REQUEST FOR LETTER OF MAP REVISION

Ford / Conquistador

Subject: Addendum #1 to the Technical Drainage Study for
LOMR for Ford/Conquistador
H T E #06-26038

TO: Chris O. Stone, P.E. *COS*
FROM: Isabel Pennington *IP*
OFFICE: Las Vegas
DATE: June 12, 2006
SUBJECT: WILLDAN / Clark County Development Services Dept. Plan Review Contract
Technical Drainage Study for Outfall of Upper Blue Diamond Detention
Basin Adjacent to the future Ford/Conquistador Residential Subdivision
(5267)
Study Dated: May 26, 2006
Location: East of the outfall of the Upper Blue Diamond Detention Basin and
north of Ford Avenue
(Sec. 18, T. 22 S., R. 60 E.)
HTE # 06-26038
Prepared by Triton Engineering

HYDRAULIC CROSS SECTIONS

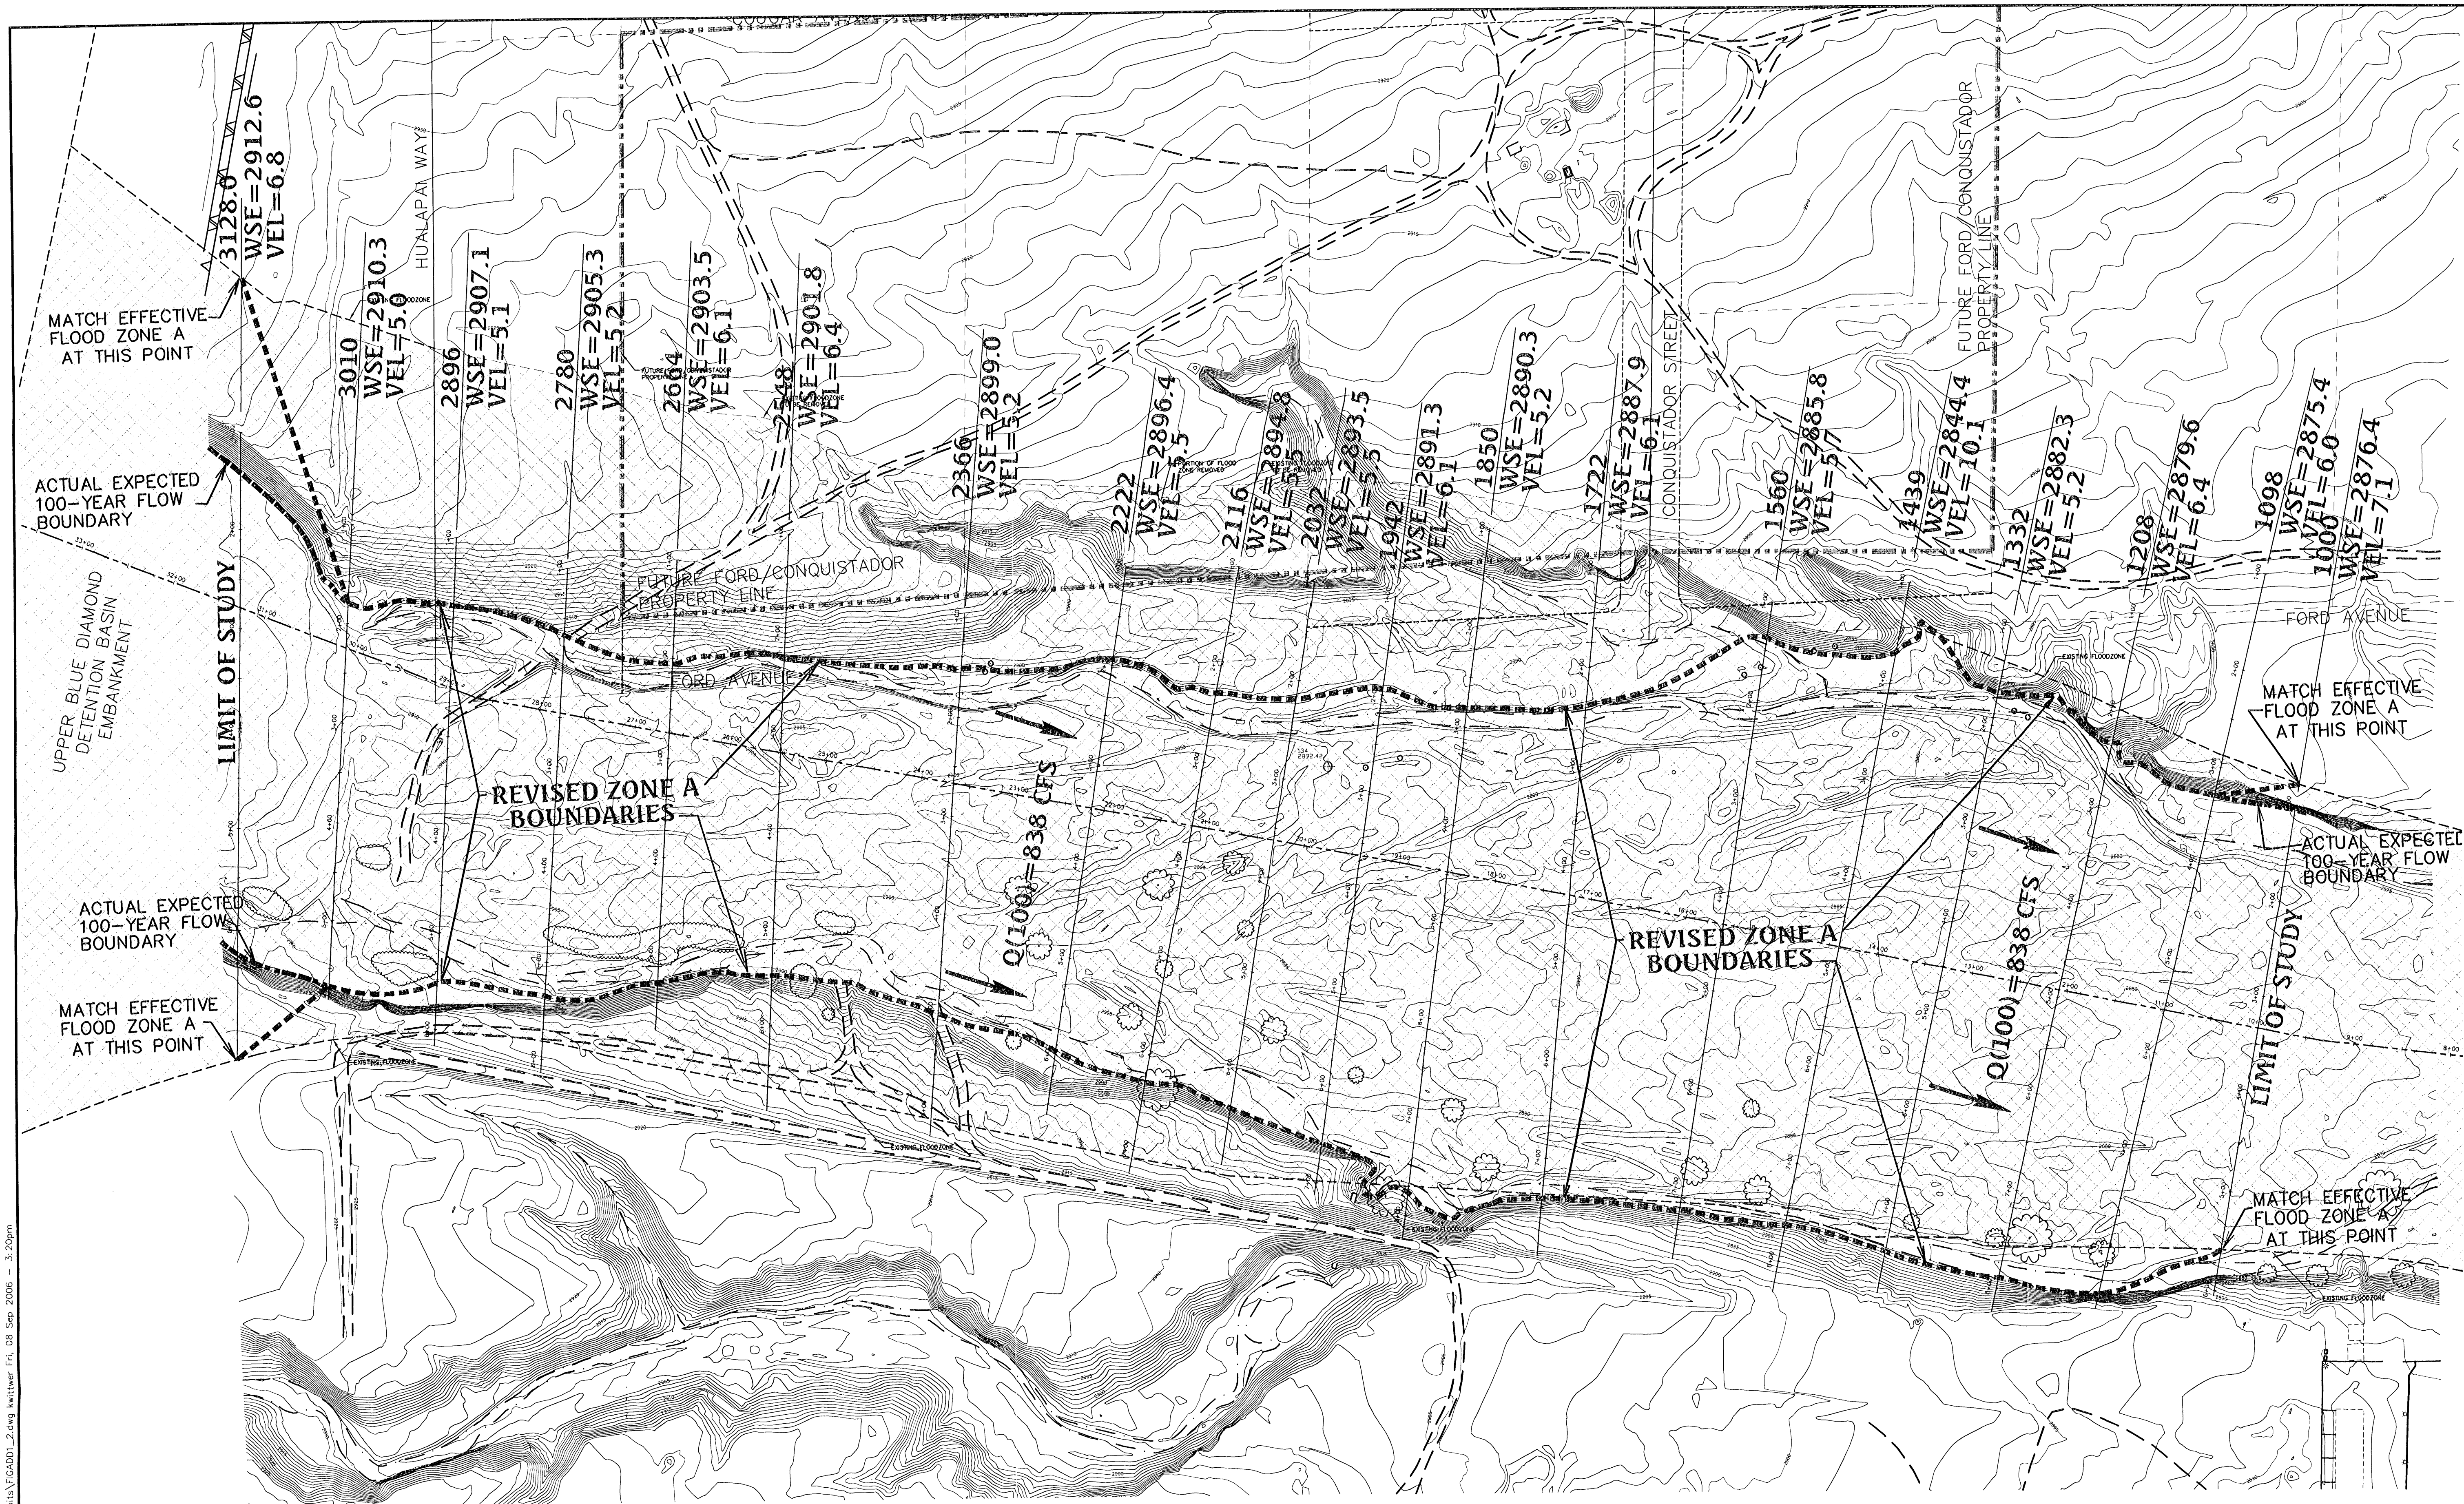
- 7. Clearly show the limits of the detention basin outfall including topography on Figure D-1(A) and extend the analysis up the toe of the basin;**

- 9. An annotated FIRM Map must be provided and the proposed flood zone delineation added to Figures D-1 (A-E);**

The exhibits and analyses have been revised to show the topography for the detention basin outfall to a distance within about 450 feet of the site. The newly-attained (April 2006) topography does not include the area of the spillway and toe of the basin, however, the topography was found to be sufficient for analysis.

The annotated FIRM Maps have been added to this submittal as Figures ADD1-3 and ADD1-4. Figure D-1 (A-E) has been replaced with Figure ADD1-2, which provides all of the pertinent topographic information, cross sections, and proposed flood zone delineation.

FIGURE ADD1 - 1

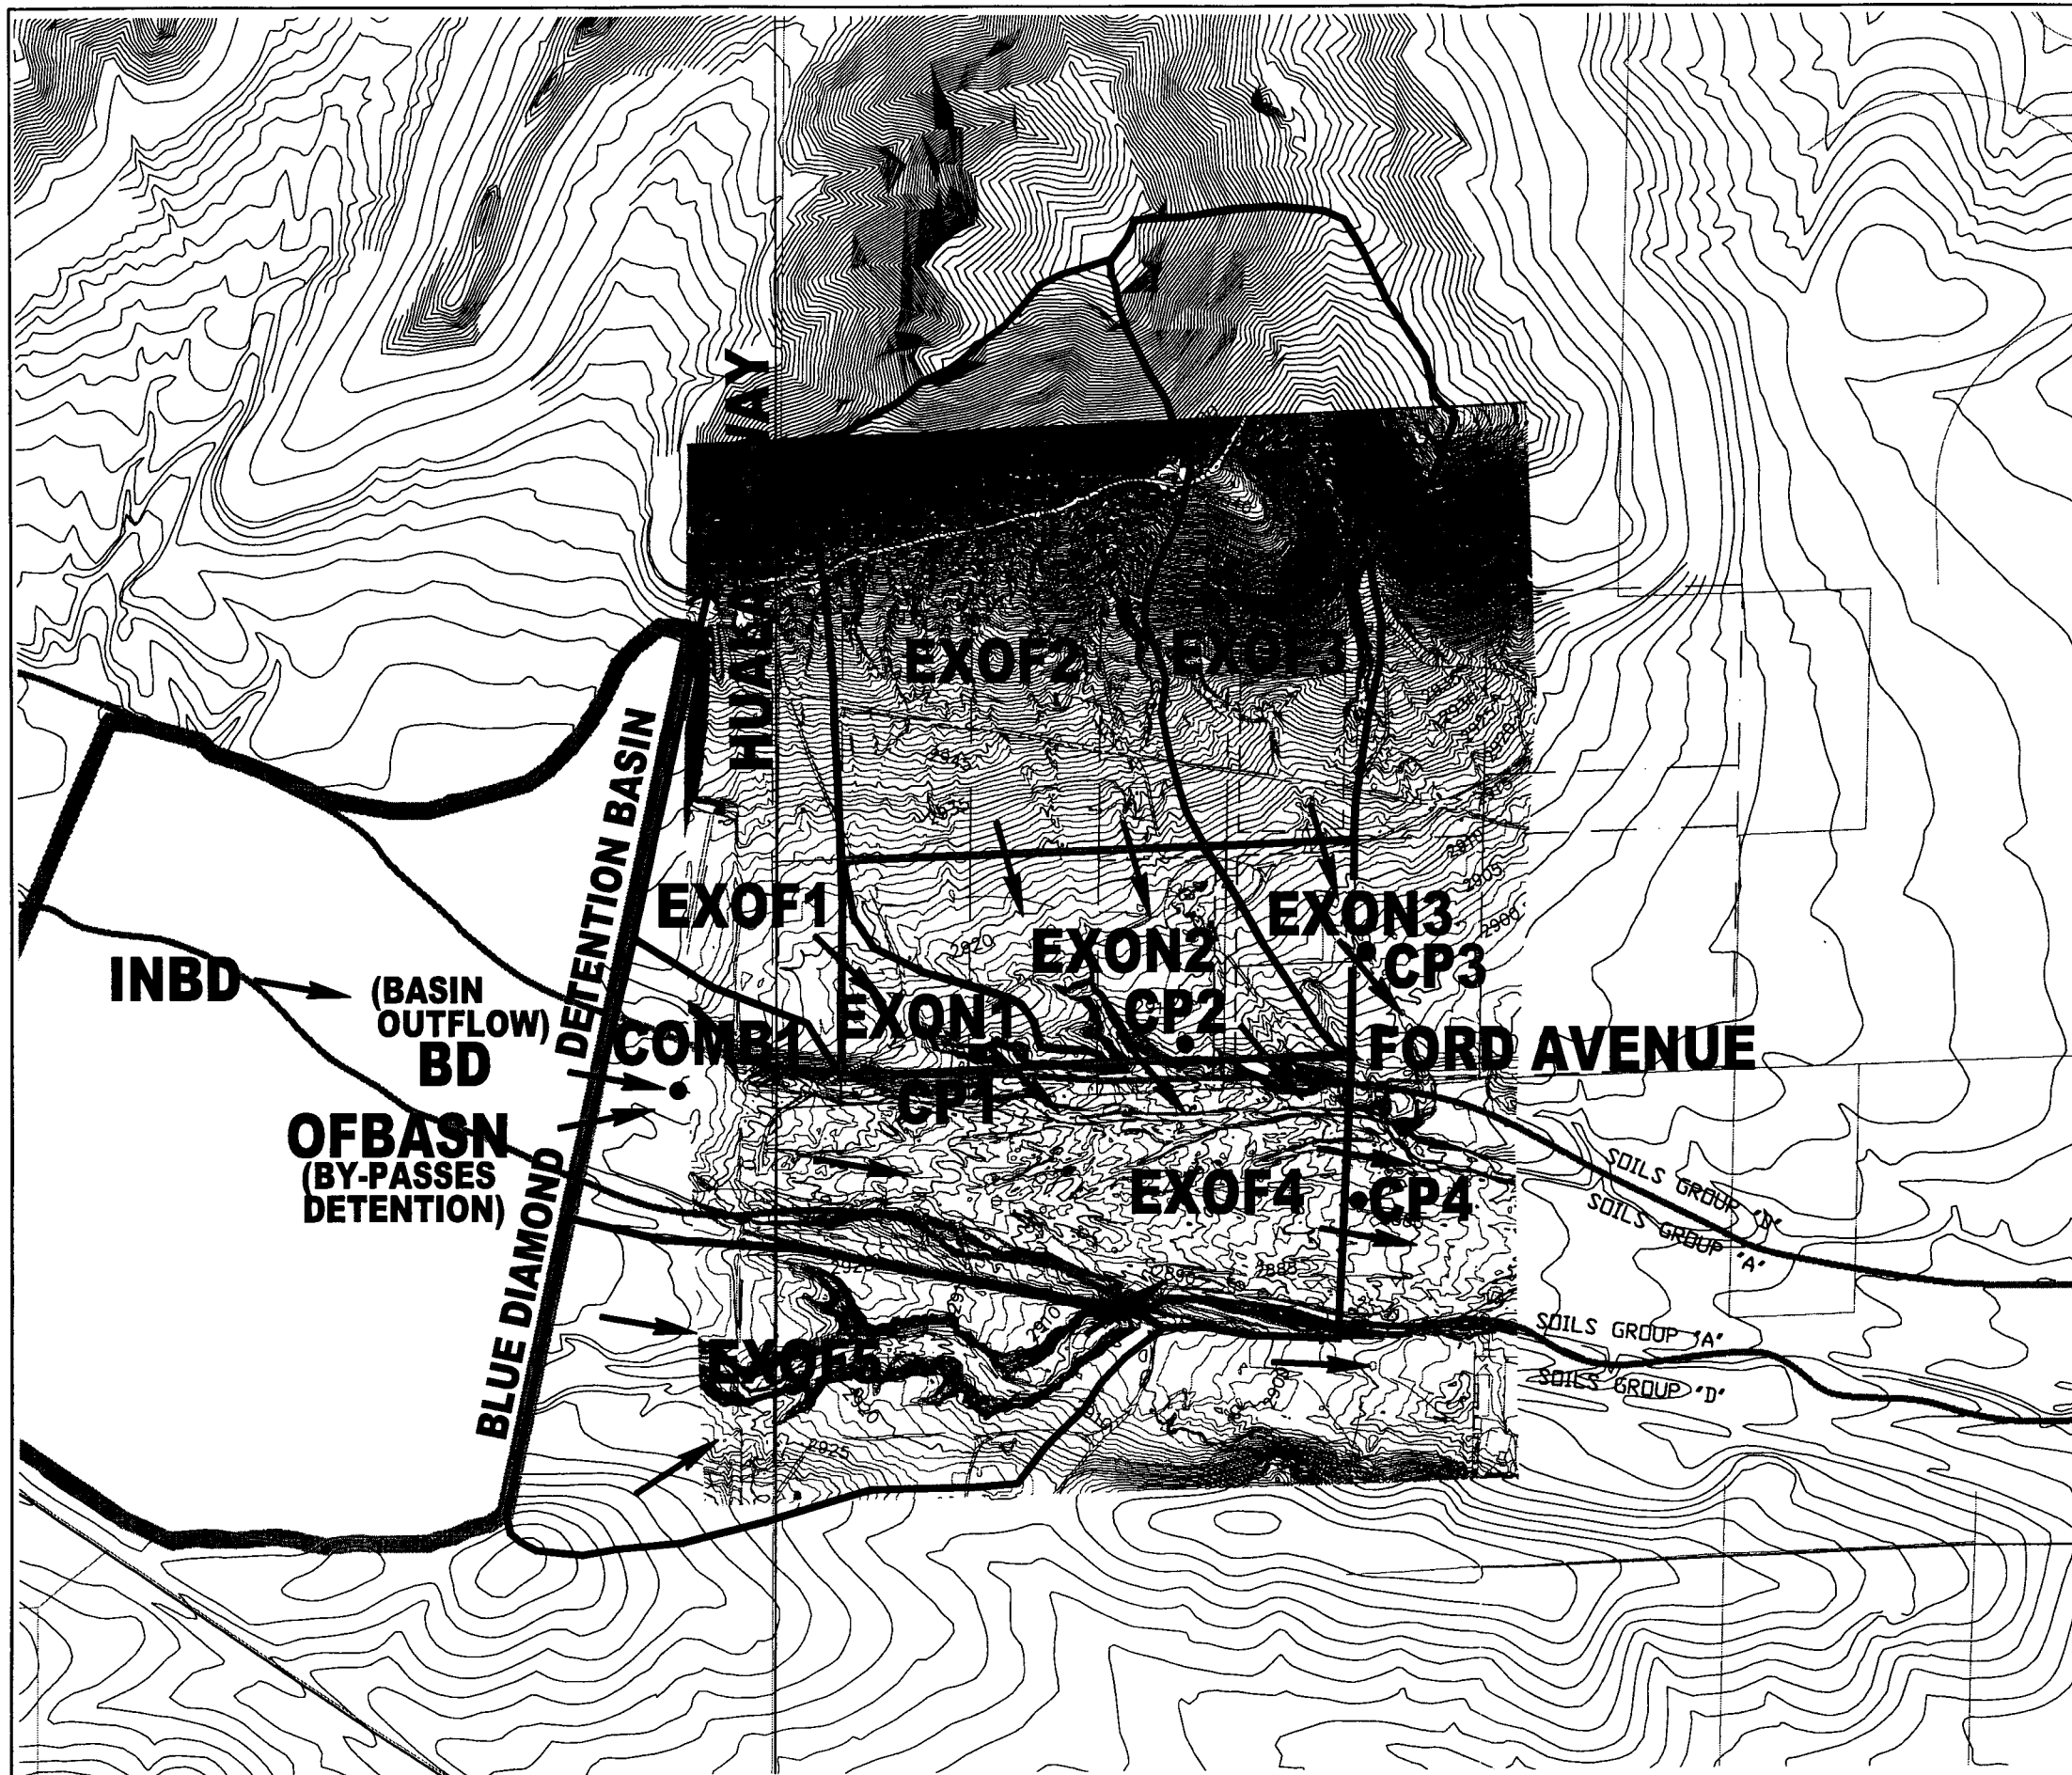
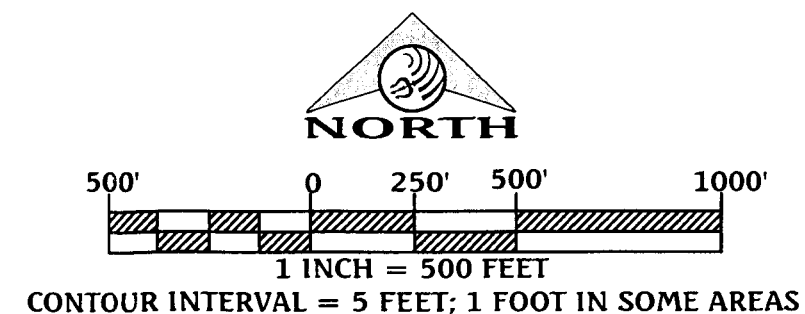
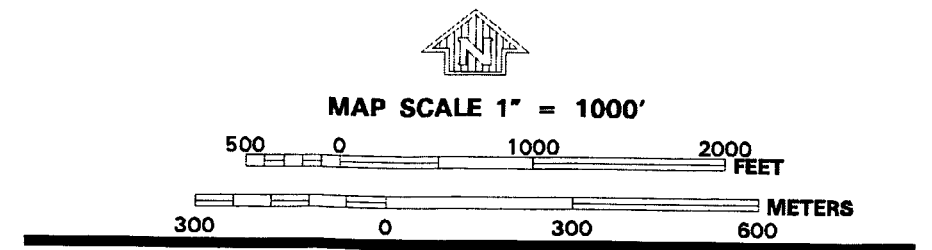
- 4. The location of the detention basin outfall must be shown on the Proposed Basin Exhibit. Also, the location of the 4-foot by 6-foot RCBC which drains offsite basin OFFSITEB must also be shown on the exhibit. A note must be provided on the exhibit indicating that the flow from basin OFFSITEB by-passes the detention basin. The exhibit must be revised accordingly.**

6. The initial/overland slope shown on Standard Form 4 for Basin 40 is too flat. Also, Basin 40 has been delineated as one basin. Since a portion of Basin 40 is located north of the wash and a portion is located south of the wash, the basin must be delineated into more than one basin in order to obtain an accurate time of concentration. Appropriate revisions to Standard Form 4 and the hydrologic/hydraulic calculations must be provided;

The hydrologic analysis has been revised herein and results are shown on Figure ADD1-1. All drainage basins upstream of the detention basin are referenced from the "Design Memorandum for Blue Diamond Detention Basin", by USACOE, 1998. The existing drainage facility and flow that by-passes the detention basin is included in the analysis as OFBASN. Referring to Figure ADD1-1, under existing conditions, runoff flow that by-passes the detention basin currently flows into a well-defined natural channel within basin EXOF5, and doesn't enter the main channel until about midway across from the subject site. However, to obtain a conservative estimate of the peak flow rates in the main channel adjacent to the subject site, the calculated peak flow rate that by-passes detention (OFBASN) is added directly to the peak outflow rate from the detention basin (BD) just downstream of the basin (COMB1).

Again referring to Figure ADD1-1, under existing conditions, runoff flow from area EXOF1 enters the subject site along the western boundary and combines with onsite flow from area EXON1 at point CP1, where it enters the main channel. Runoff flow from area EXOF2 enters the site along the northern boundary, and combines with onsite flow from area EXON2 at point CP2, where it enters the main channel. Runoff flow from area EXOF3 enters the subject site also along the northern boundary, combining with onsite flow from area EXON3 at point CP3, where it exits the site along the eastern boundary, across several natural drainage paths. Note that within area EXOF3 there is a very well-defined alluvial fan along the base of the adjacent mountain range. Although it appears that under existing conditions, the main flow path from the fan may be toward the east, away from the subject site, it is most conservative to assume that runoff from the fan could easily change direction and flow toward the subject site. Research of the previously-approved school site located east of the subject site indicates that the runoff flow from the majority of area EXOF3 and its associated alluvial fan was included in their analysis as passing completely toward their site to the east. Again, it is evident that even though the runoff flow appears to trend toward the east under existing conditions, it was found to be most conservative to assume that all of this alluvial runoff flow (EXOF3) would impact the subject site.

The hydrologic and hydraulic analyses have been revised herein. Results of the hydrologic analysis are summarized on Figure ADD1-1, and described in the response to comment 4 above.

The exhibits and analyses have been revised and are included herein. Hydrologic Soils Group types are shown on Figure ADD1-1 herein and CN calculations are tabulated on a spreadsheet herein.
